OGS, MANCHESTER PROPOSED PLANNING AMENDMENTS - Z2

180146

June 2021 - Revision A

MASSING & SERVICE STRATEGY
PROPOSED ARRANGEMENT

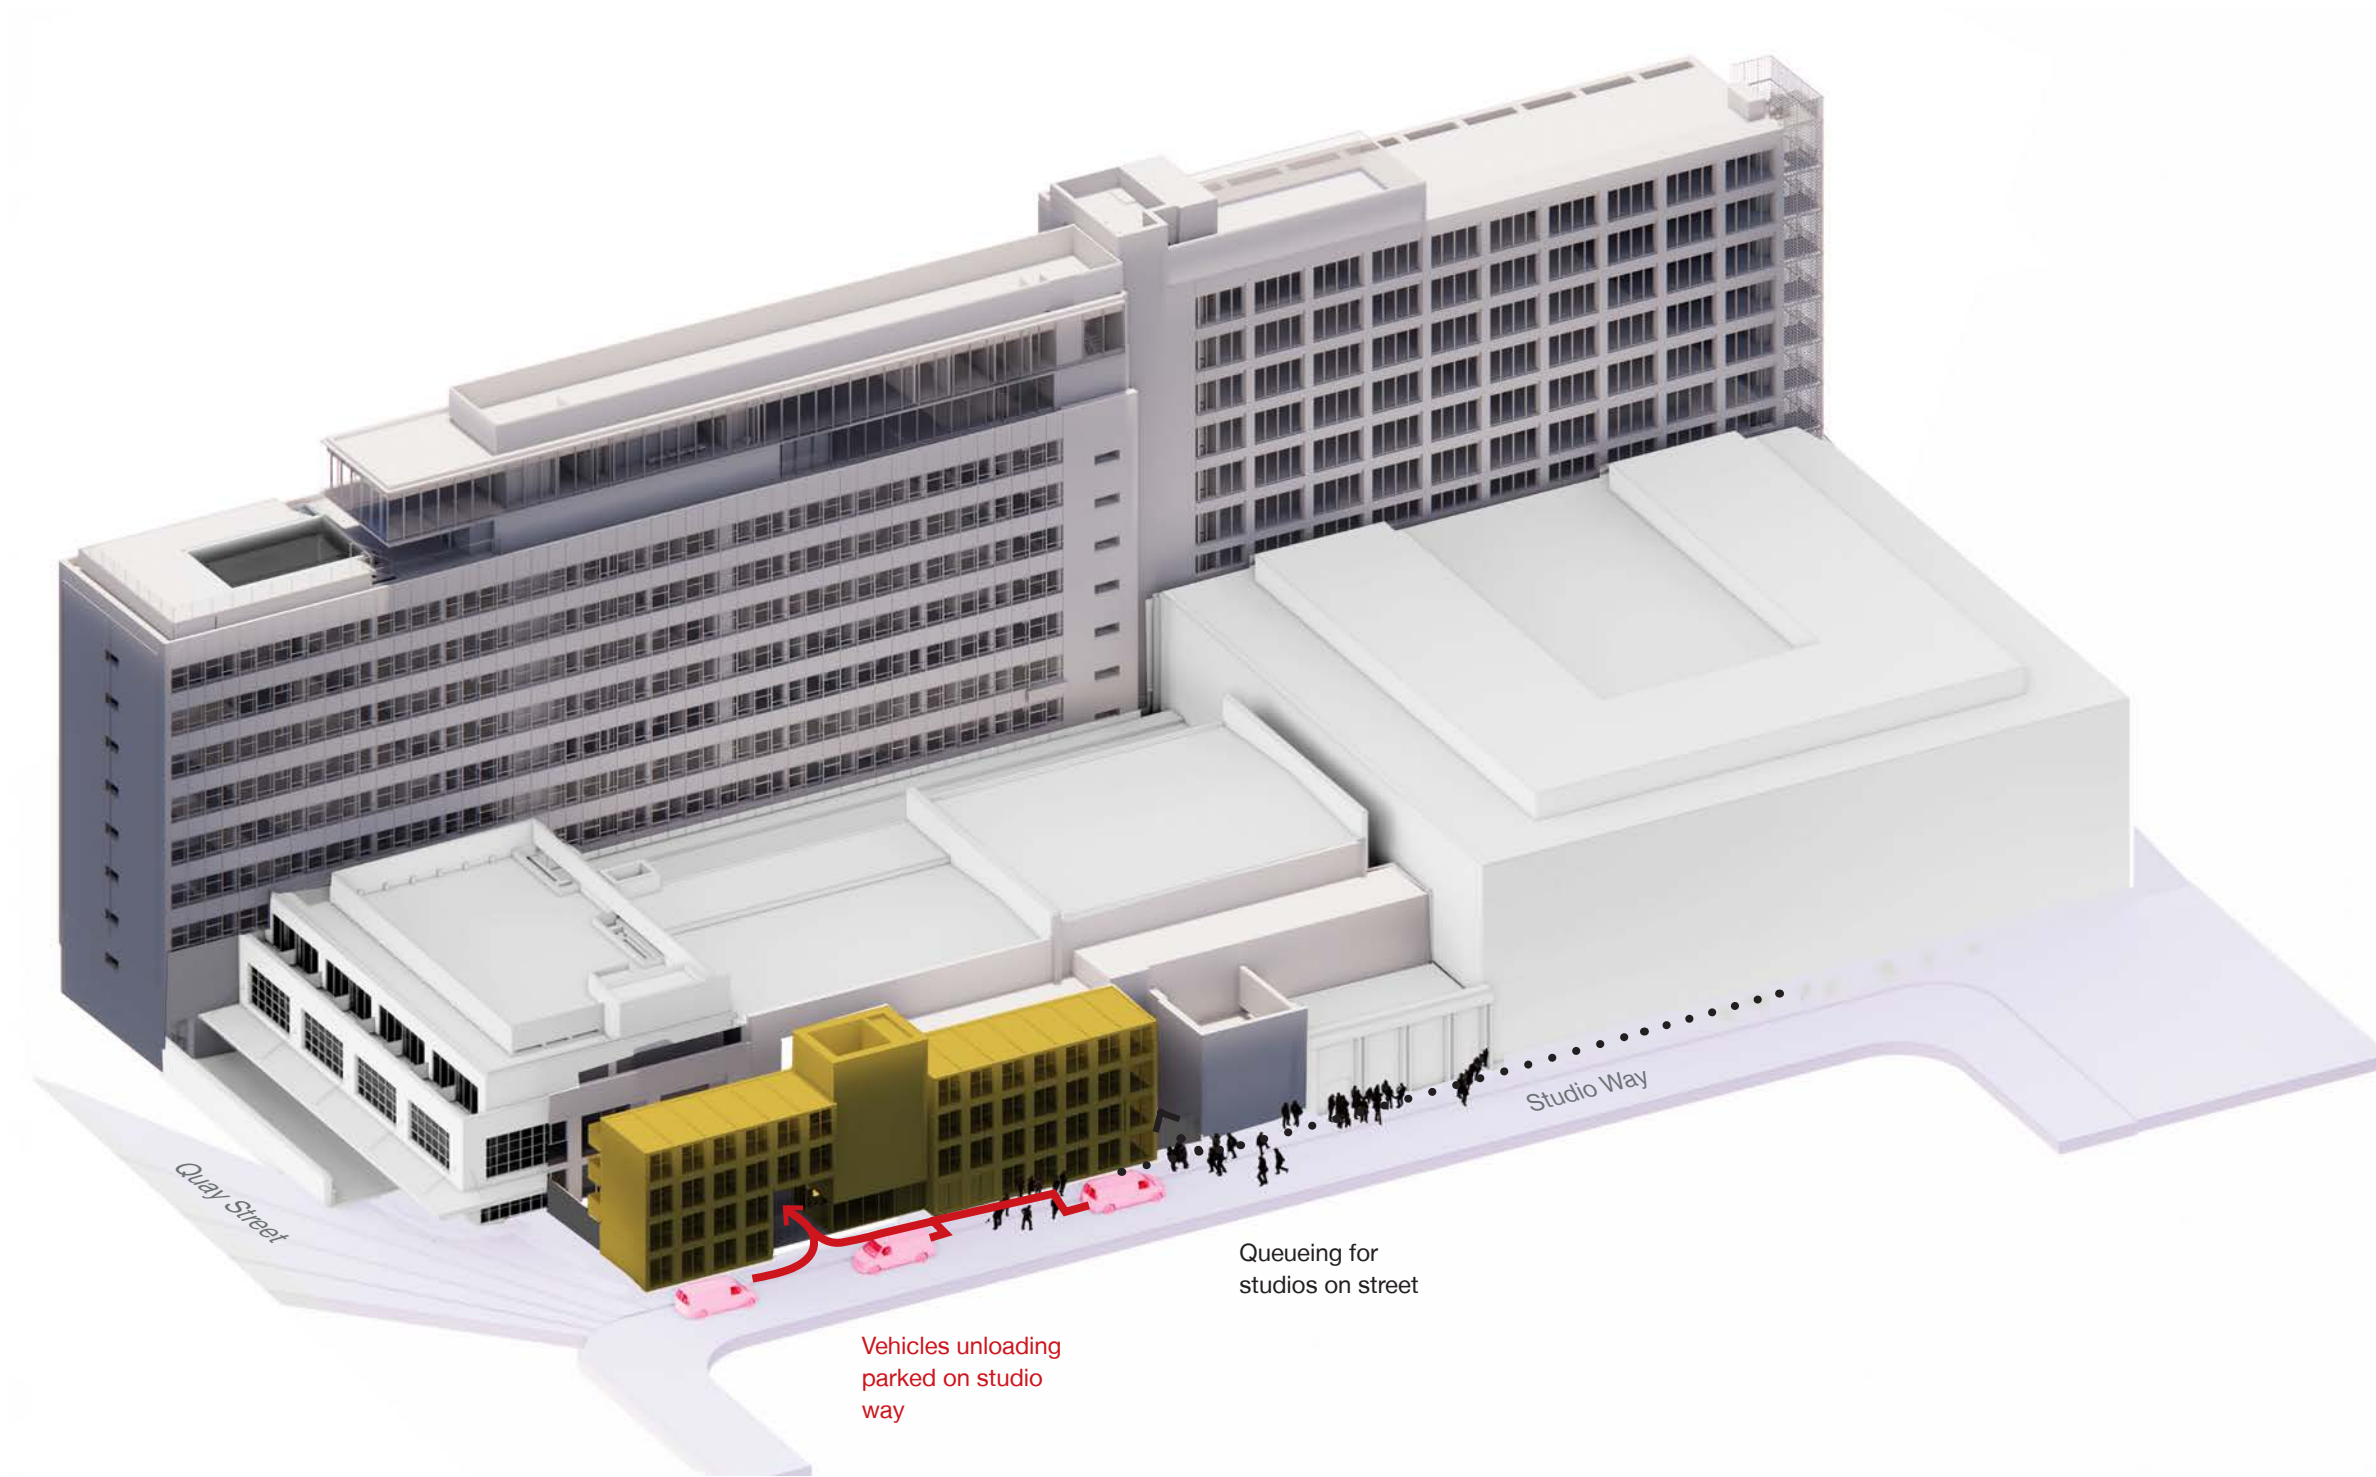
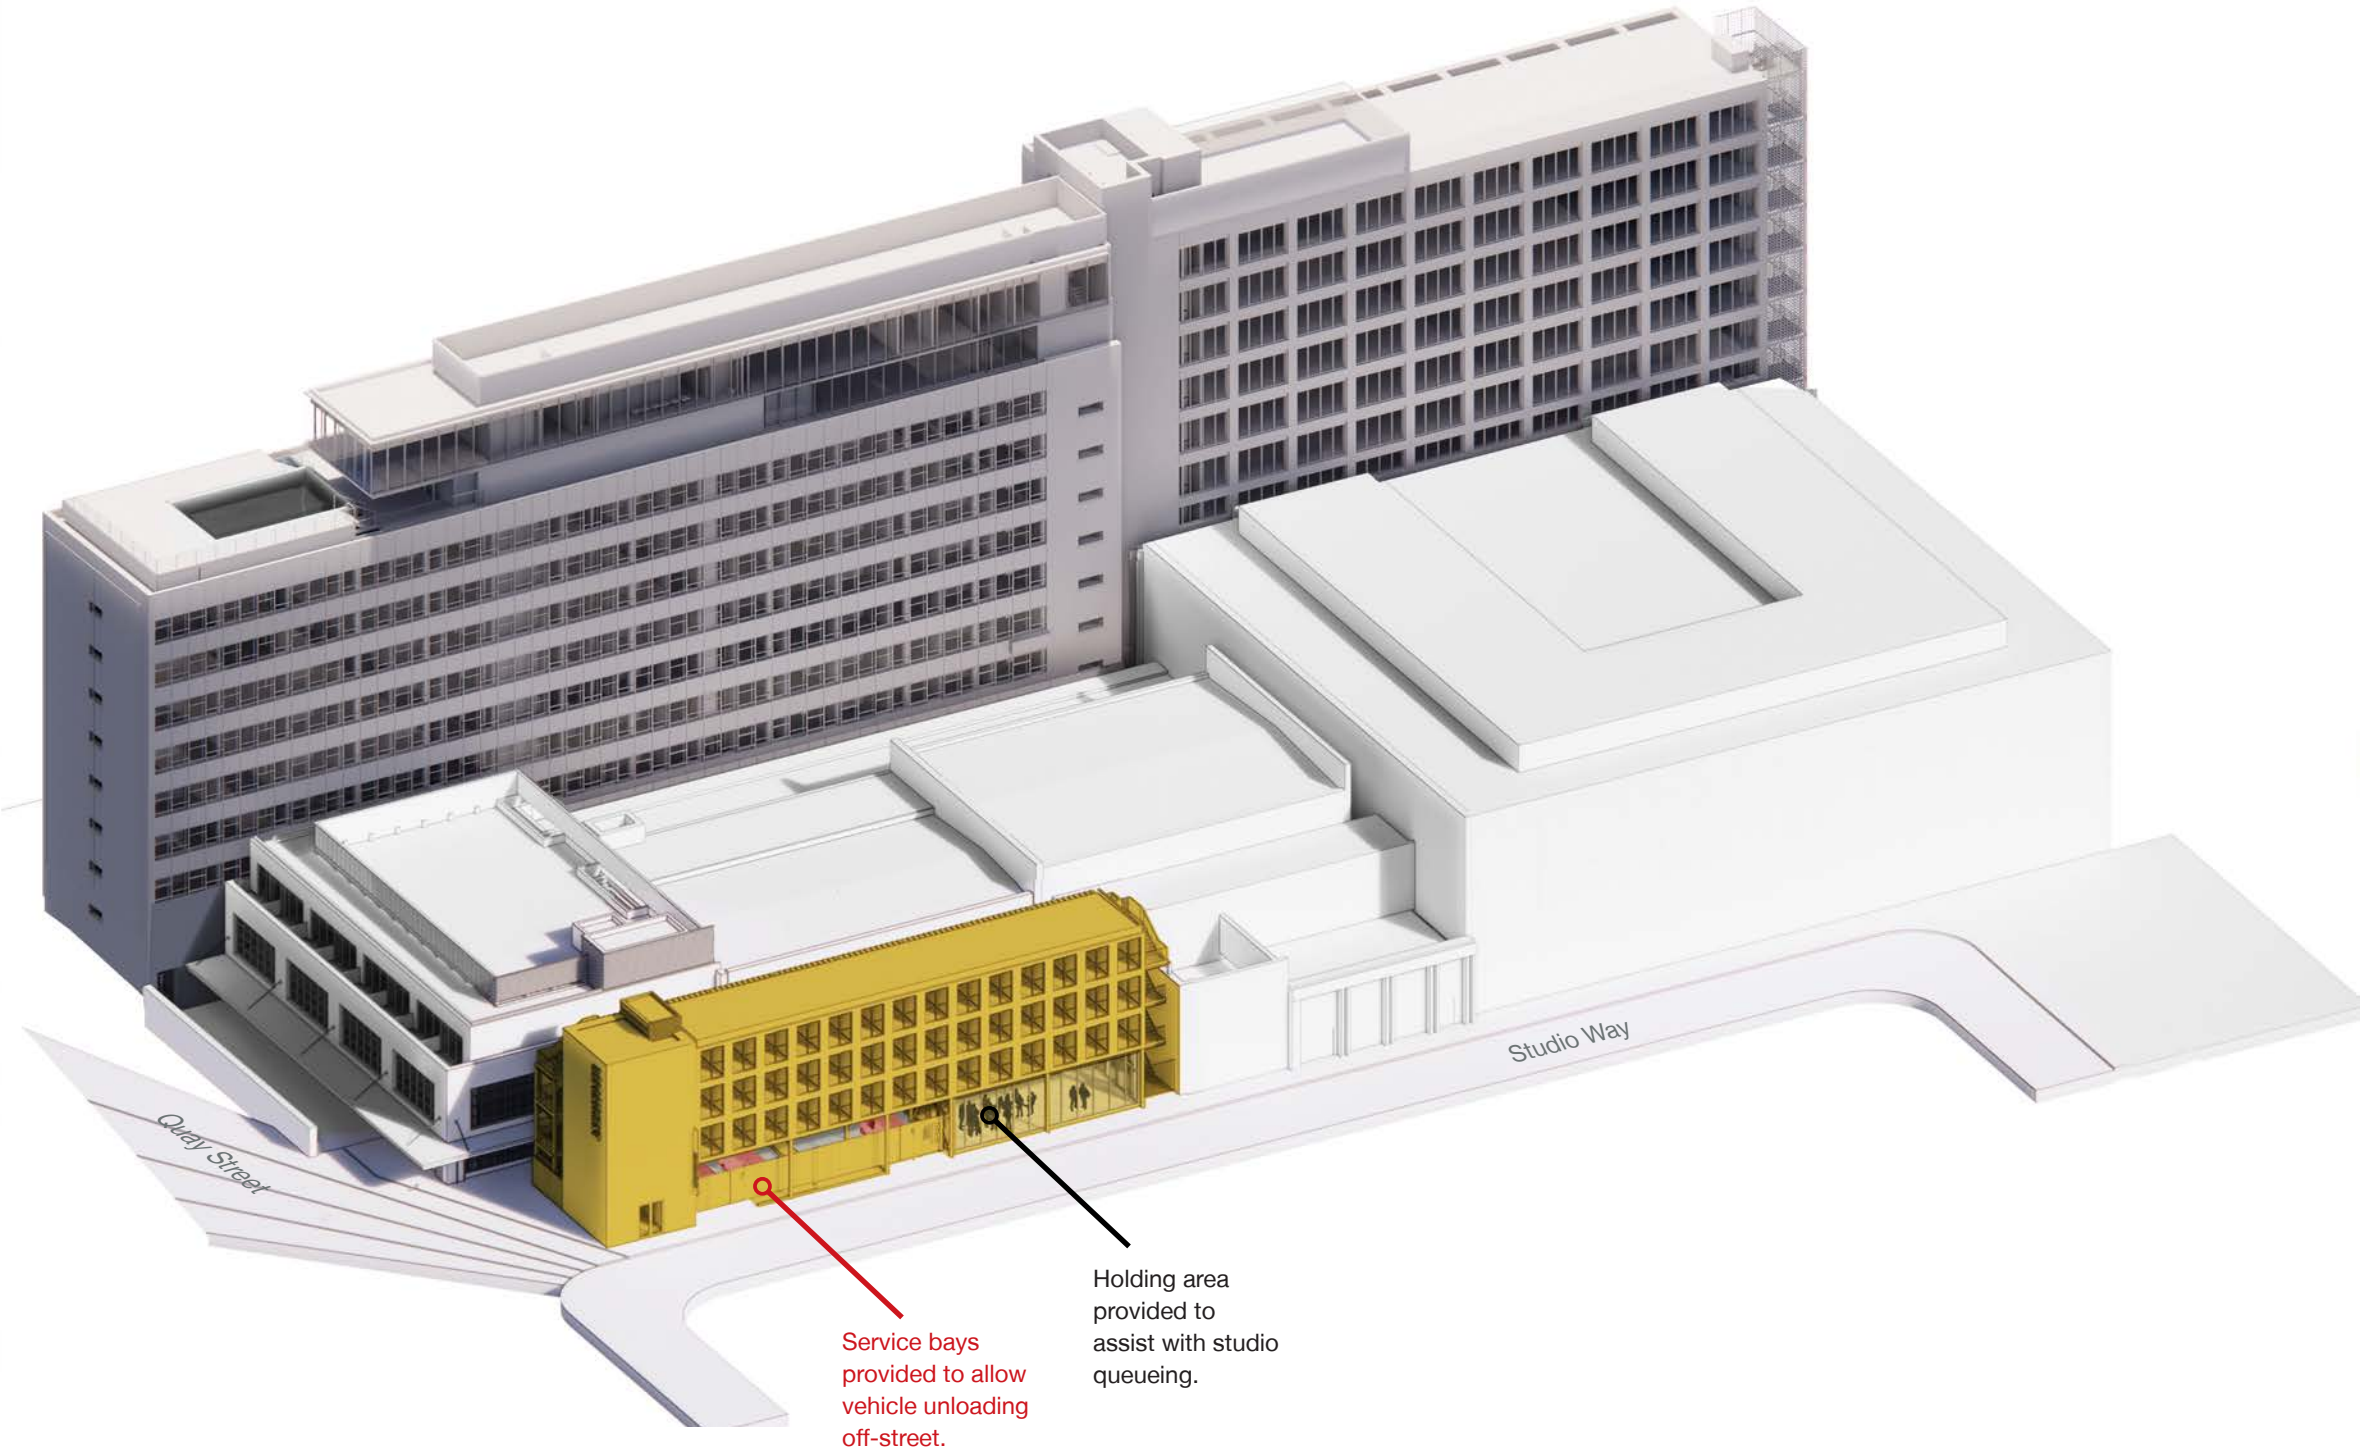
It has become clear that previous servicing arrangements to the rear of Mollies/ Studios, accessed via a narrow courtyard behind the modular workspace, were inadequate. Regular deliveries will be required for the F&B/ Hotel use classes, and a requirement for off-street audience queuing space, has driven the team to develop a revised stack for the building.

These changes offer dedicated servicing and audience access via demised service yards, situated directly below the modular workspace, which has been lifted above podium level.

SUMMARY OF MAIN UPDATES
PROPOSED DIAGRAM

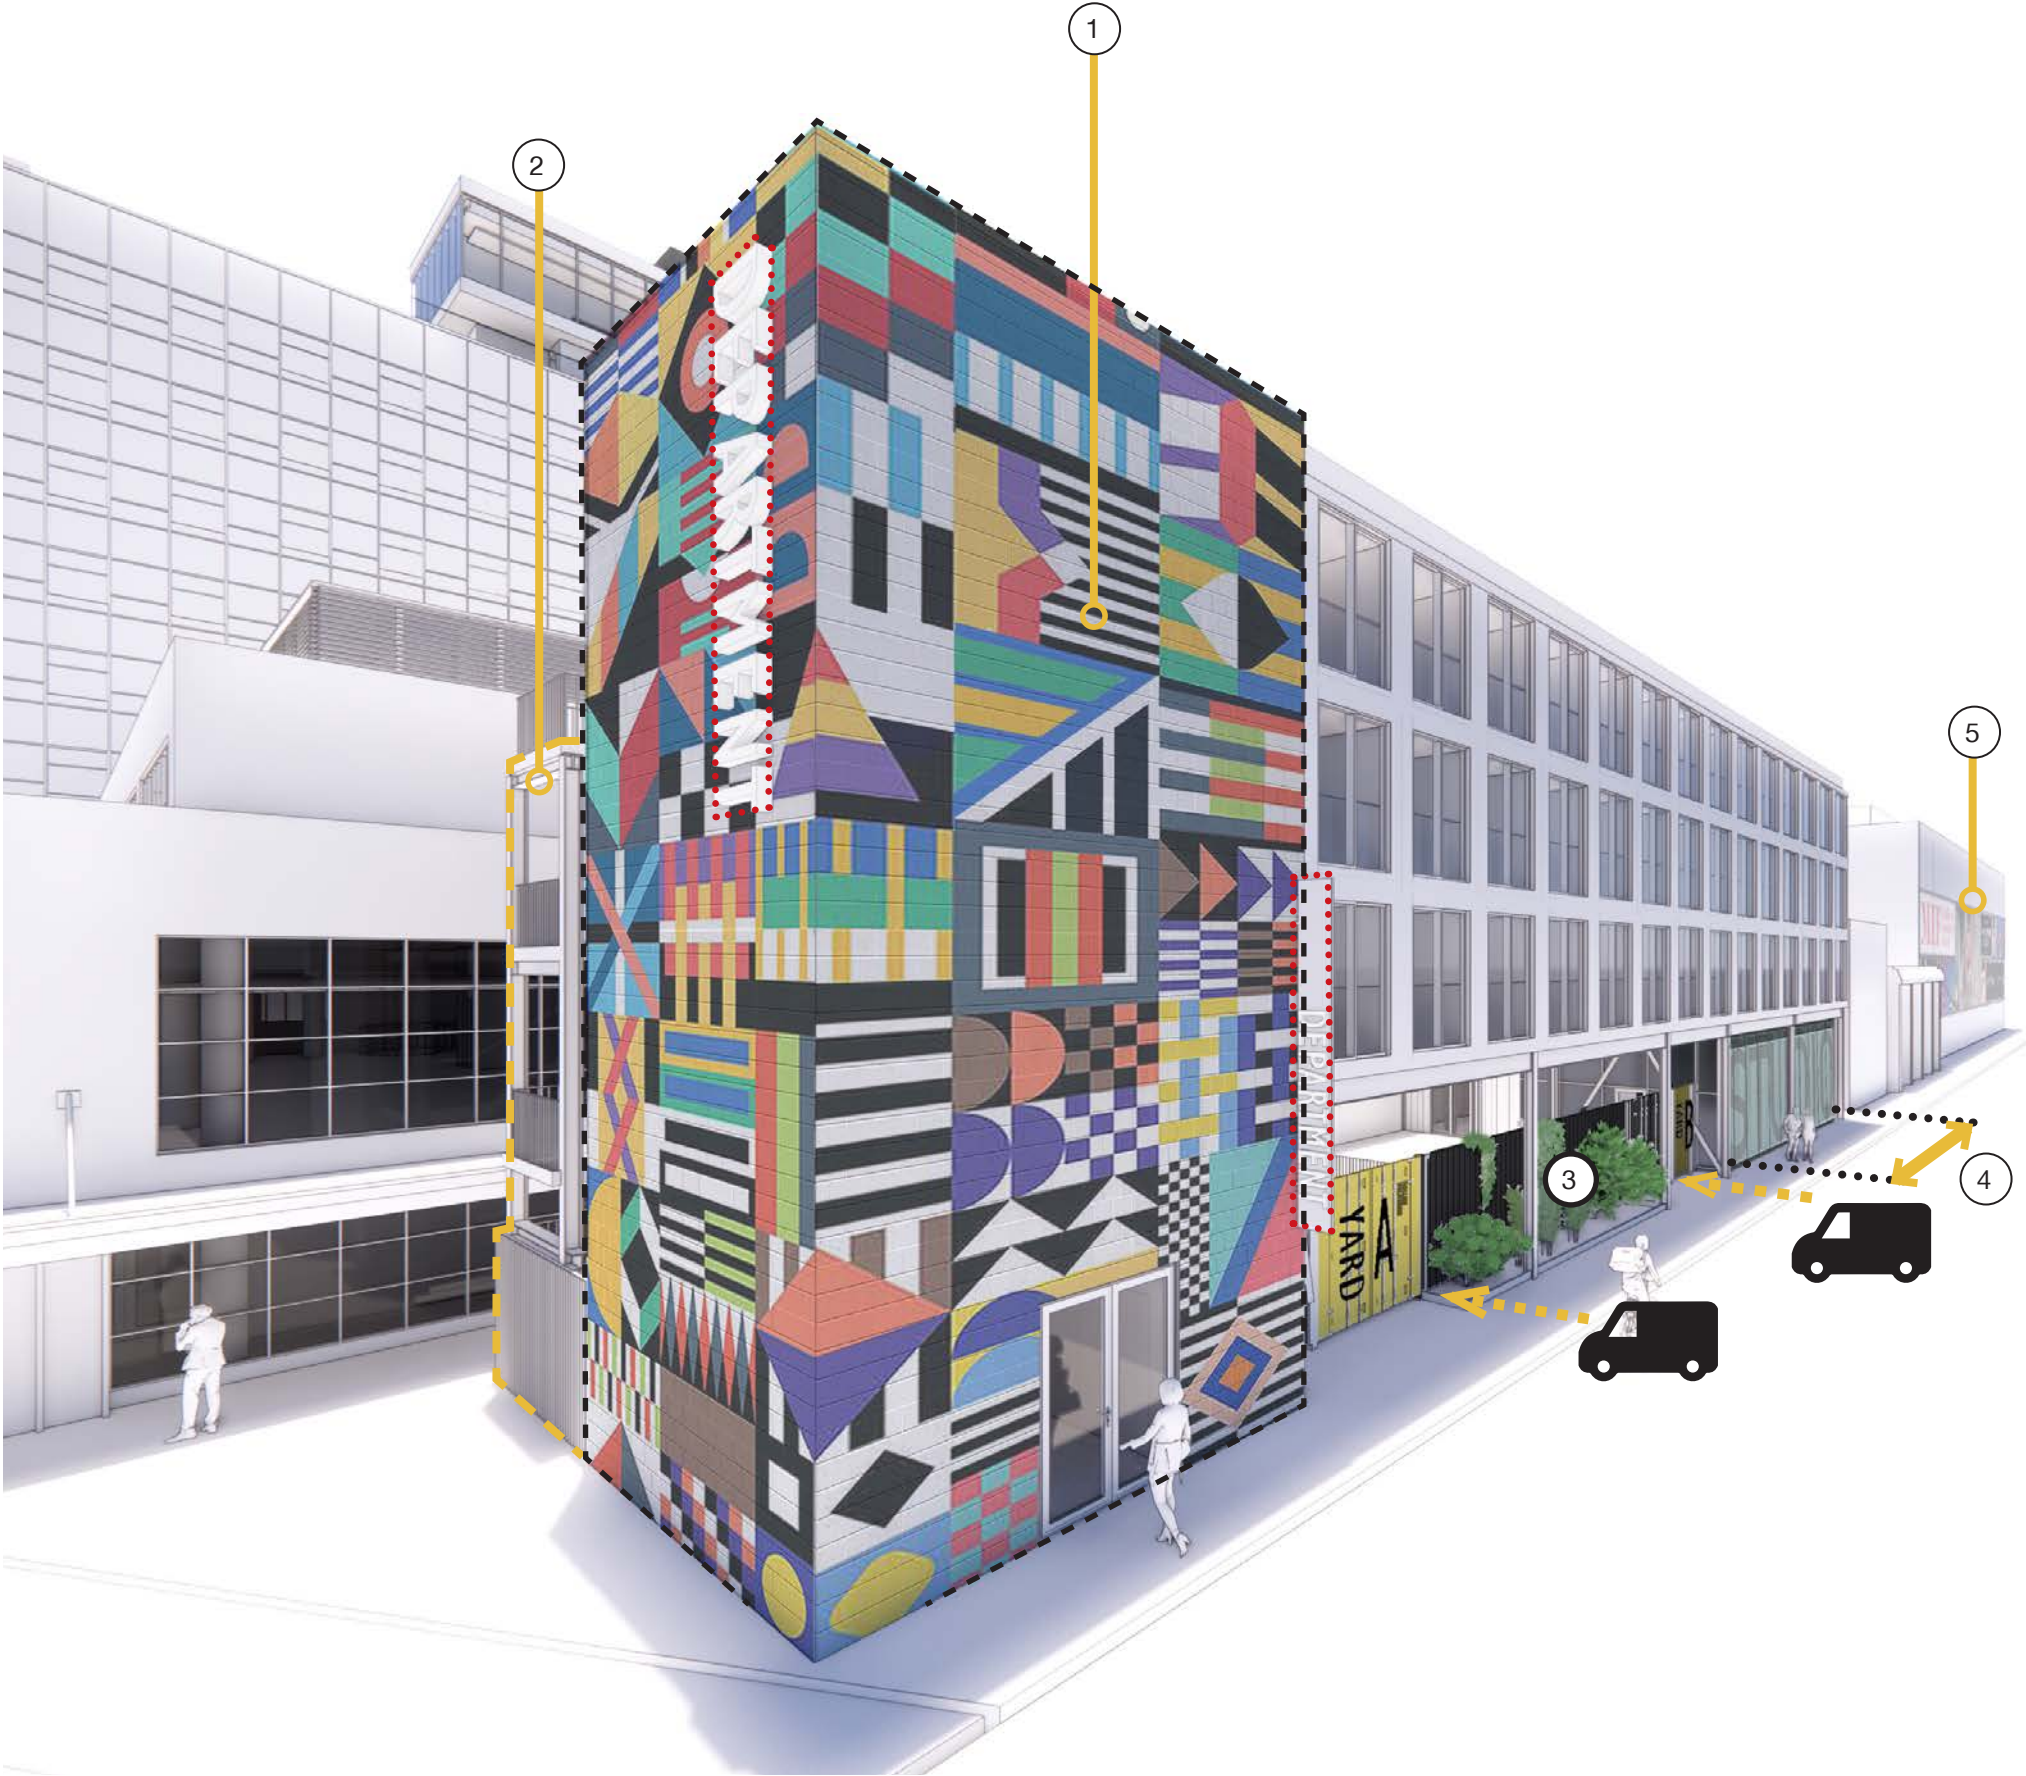
- 1 The Workspace core that provides entry & access to the upper floor shipping containers has moved to the Quay St/Studio Way corner to provide distinct entrances between the Workspace & Manchester Studios.. Super-graphic to blockwork core proposed.
 - 2 An additional stair has been added to provide second means of escape & also allow access adjacent to the relocated core.
 - 3 A service area has been provided to allow service vehicles to unload off-street. The ground floor treatment has been re-considered & includes an area for planting.
 - 4 Queueing area and holding space provided for studios. Better defined entrance & separation from workspace.
 - 5 The strategy for the studio wall has been considered & a location for artwork & advertising has been suggested.
- Indicative location of signage (separate application to be submitted).

- The height of the new scheme has increased;
- Ground to first floor height has increased to allow for service vehicles unloading off street.
 - The containers have increased from a standard shipping container (2.59m) to a High Cube shipping container (2.89m). This is to provide a ceiling height that provides more useable area for the new tenant.
 - The main elevation of the proposed shipping containers & the core is within the height of the adjacent Diner. The proposed lift over-run is below the height of the studios.
